TO: David D'Amico, Director of Public Services, Town of Medway
FROM: Michael Sanders, PE, Kleinfelder
DATE : 6/12/2019
SUBJECT: **Additional Water System Hydraulic Analysis for Timber Crest Estates Development**
CC: Kirsten Ryan, Kleinfelder; file

"TIMBER CREST ESTATES & KINGSBURY VILLAGE"
WATER CONNECTION PRESENTATION
IN
MEDWAY, MASSACHUSETTS

Figure 1: Fire flow node location plan (Not to Scale)

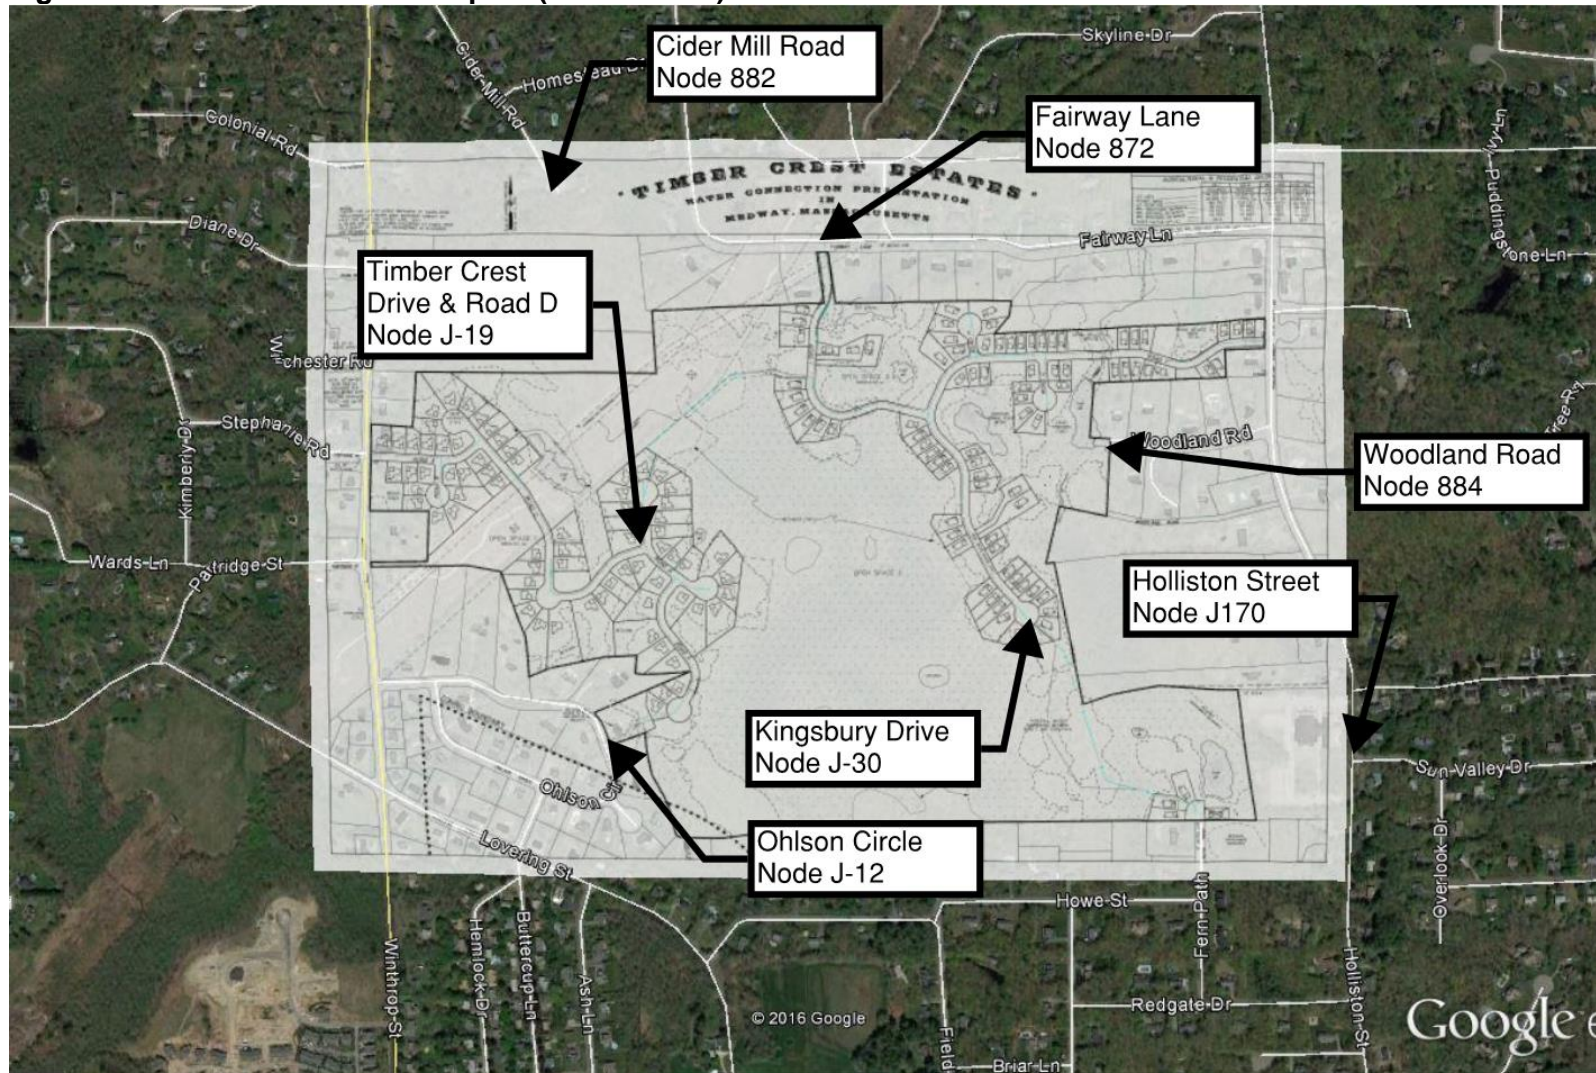
Table 3 above shows that available fire flow within the development is sufficient under scenarios 2, 3 and 4. Scenario 1 does not meet the development's fire flow requirements because the south end of Kingsbury Drive (J-30) is deficient.

Also, the addition of the Timber Crest Estates development does not reduce the available fire flows in the surrounding neighborhood below the needed fire flows.

Kleinfelder recommends that the development include the improvements outlined in Scenario 2, 3 or 4 as described in Section 3. This requires that the water main in Kingsbury Drive be sized at least 10-inches in diameter. Additionally, Kleinfelder recommends that the developer mitigate the anticipated low domestic water pressures in this new development. This may involve installing a booster pump in each home or a single, larger pump system to serve the entire development that will increase system pressure above minimum MassDEP recommendations. A single, larger pump station will have long-term operation and maintenance requirements and the Town would not take ownership of such a system.

Scenario 2

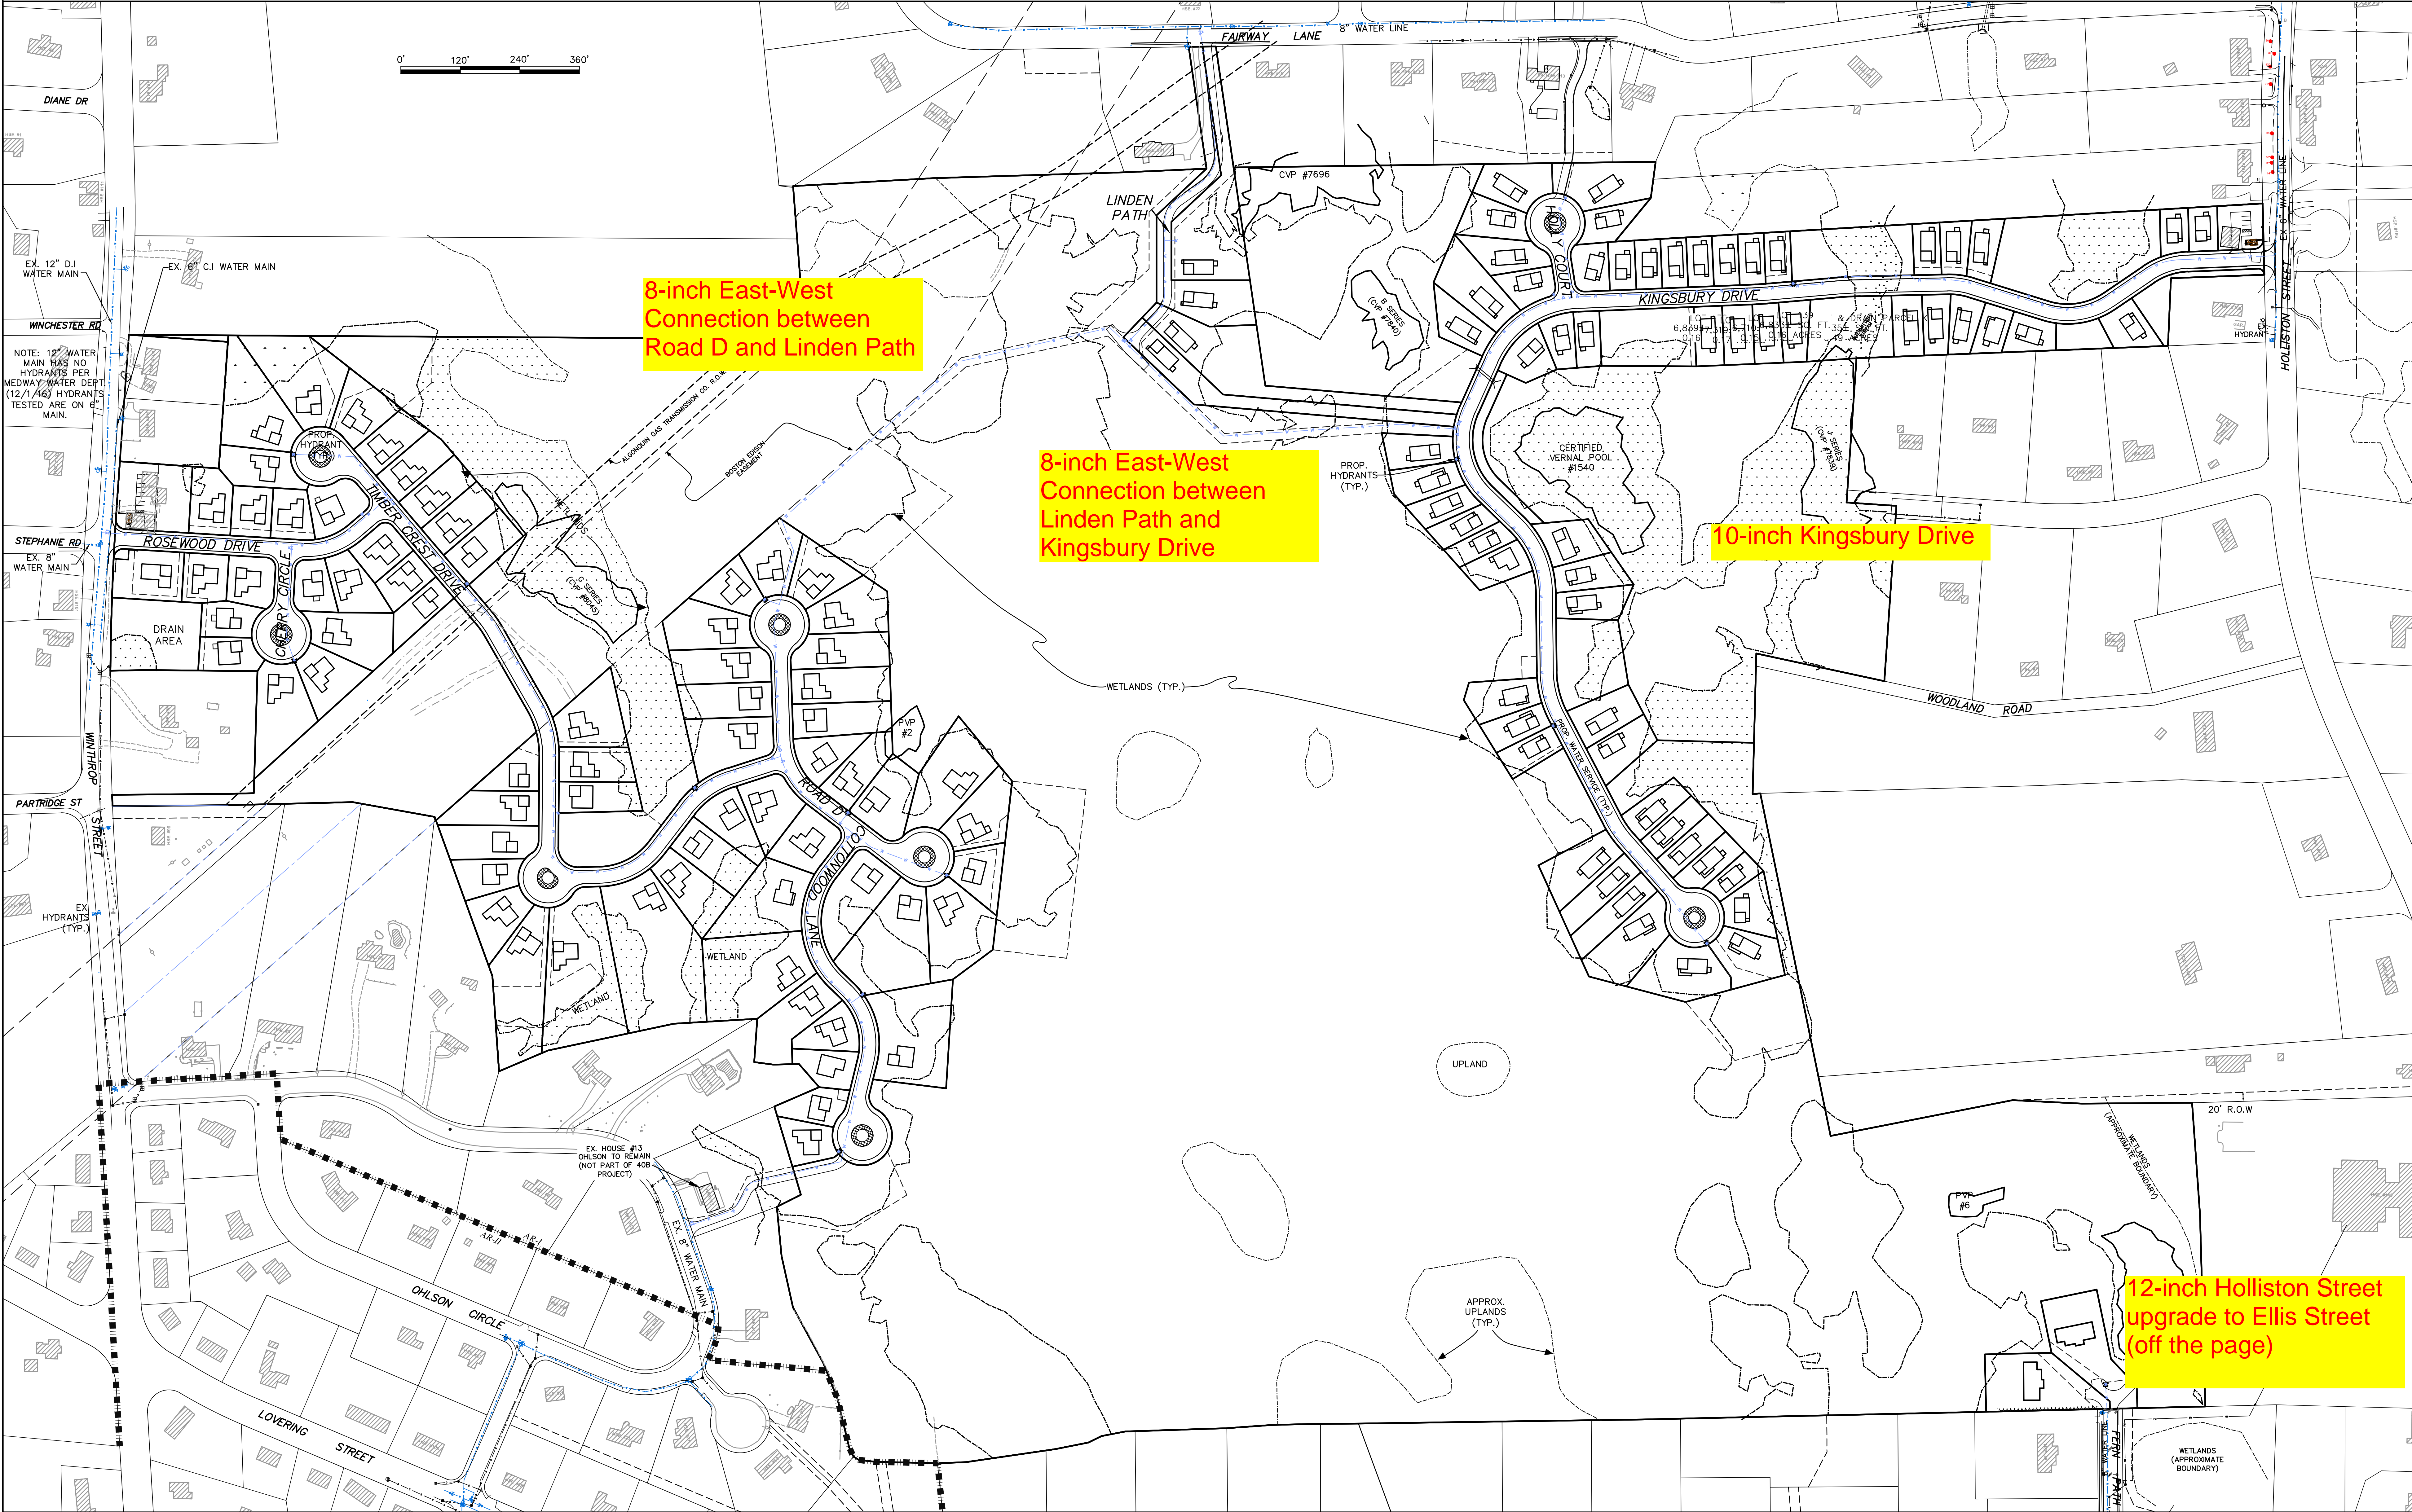
8-inch East-West
Connection between
Road D and Linden Path

8-inch East-West
Connection between
Linden Path and
Kingsbury Drive

10-inch Kingsbury Drive

12-inch Holliston Street
upgrade to Ellis Street
(off the page)

Scenario 3

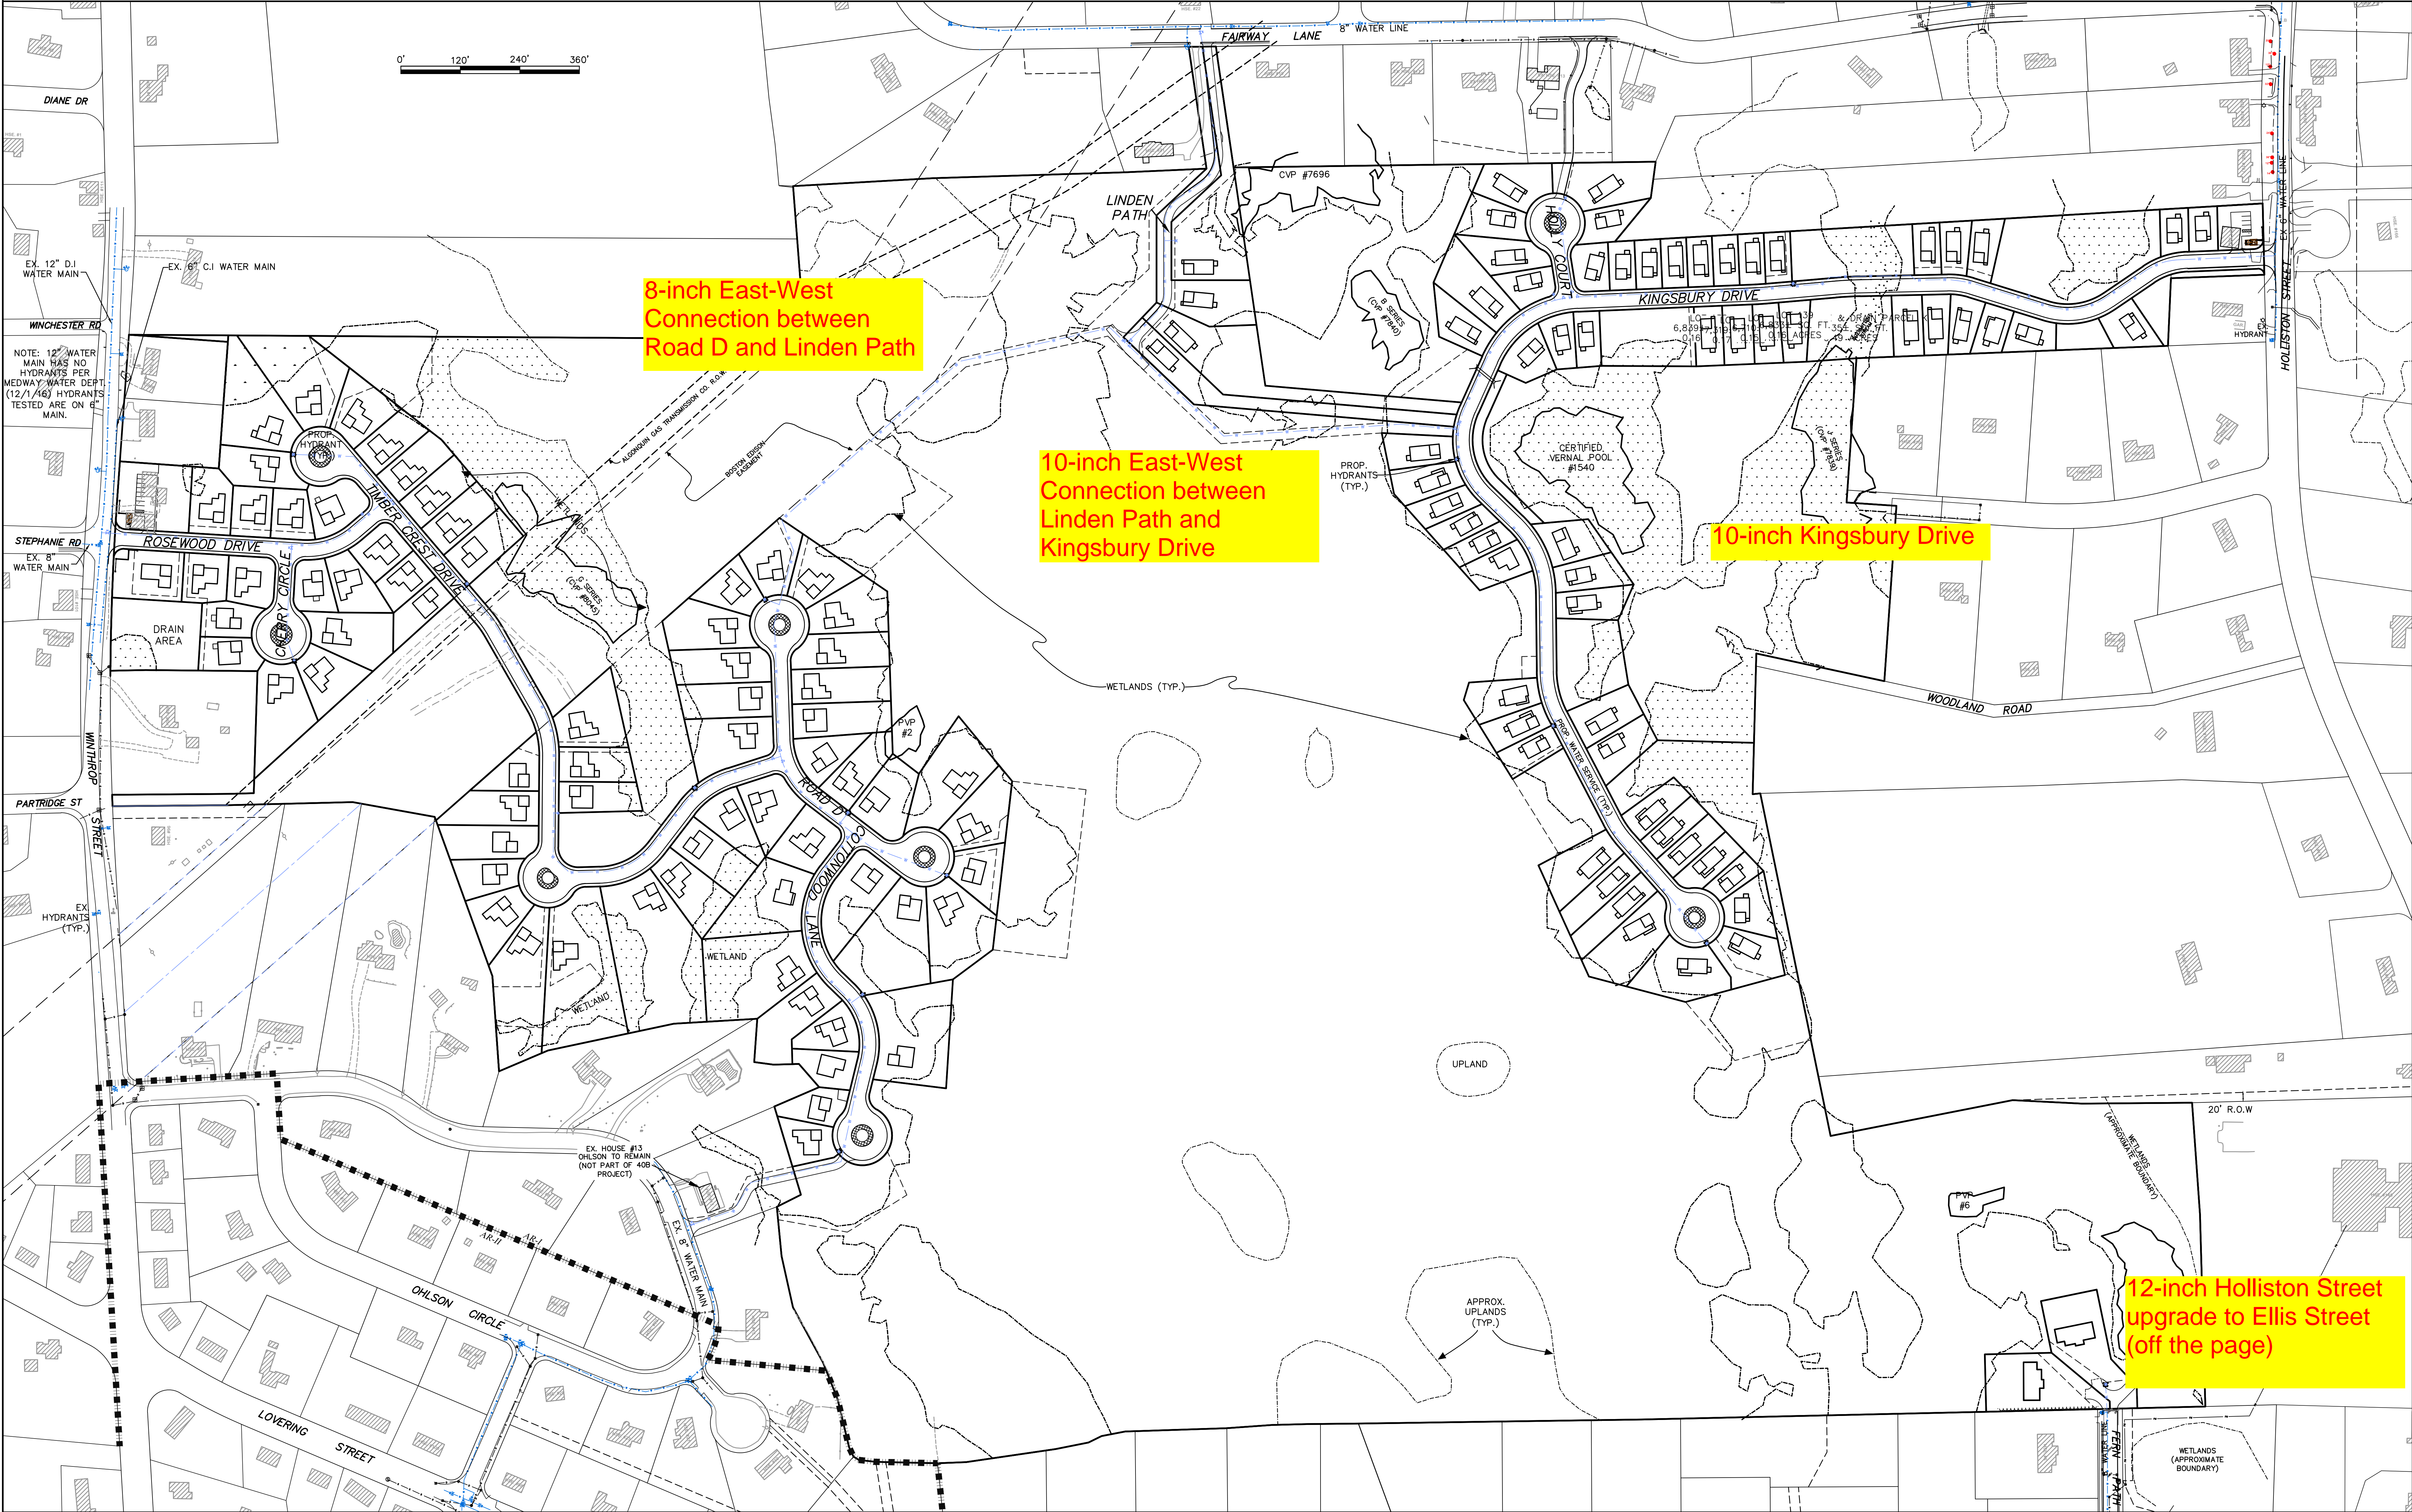
8-inch East-West
Connection between
Road D and Linden Path

10-inch East-West
Connection between
Linden Path and
Kingsbury Drive

10-inch Kingsbury Drive

12-inch Holliston Street
upgrade to Ellis Street
(off the page)

Figure 1: Improvement options presented by Outback Engineers for hydraulic analysis

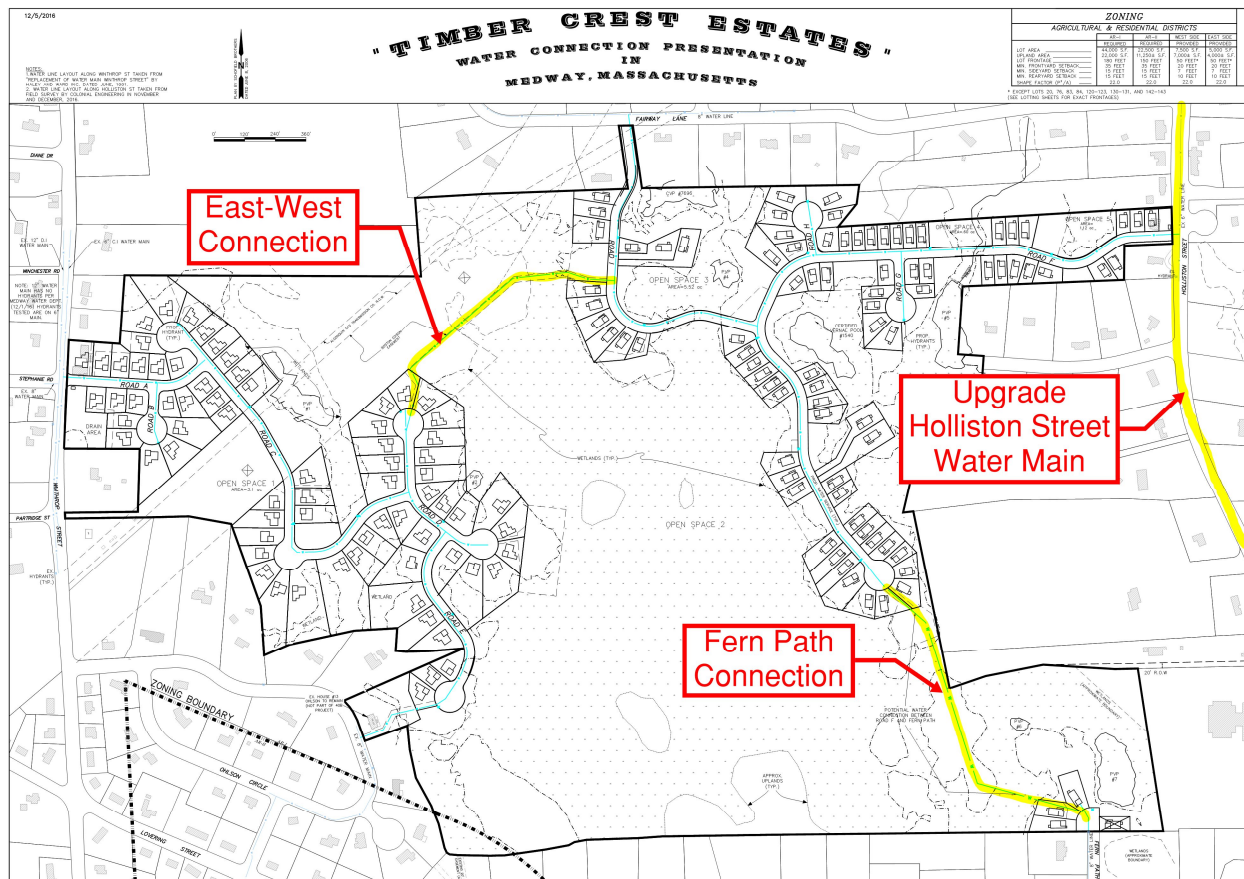
development. The connections to the existing Town of Medway water system are shown at Winthrop Road, Fairway Lane, Holliston Street and Ohlson Circle. An option for an additional connection to the existing system is shown that would connect proposed Road F to the existing 6-inch water main in Fern Path. Another option is shown that would connect the east side of the development to the west side of the development between Road D and Road I. Kleinfelder was also asked to evaluate the impact of an upgraded Holliston Street water main from 6-inch diameter to 12-inch diameter from Lovering Street north to the Town Line. Figure 1 below highlights the “East-West” connection, the Fern Path connection and the Holliston Street water main upgrade.
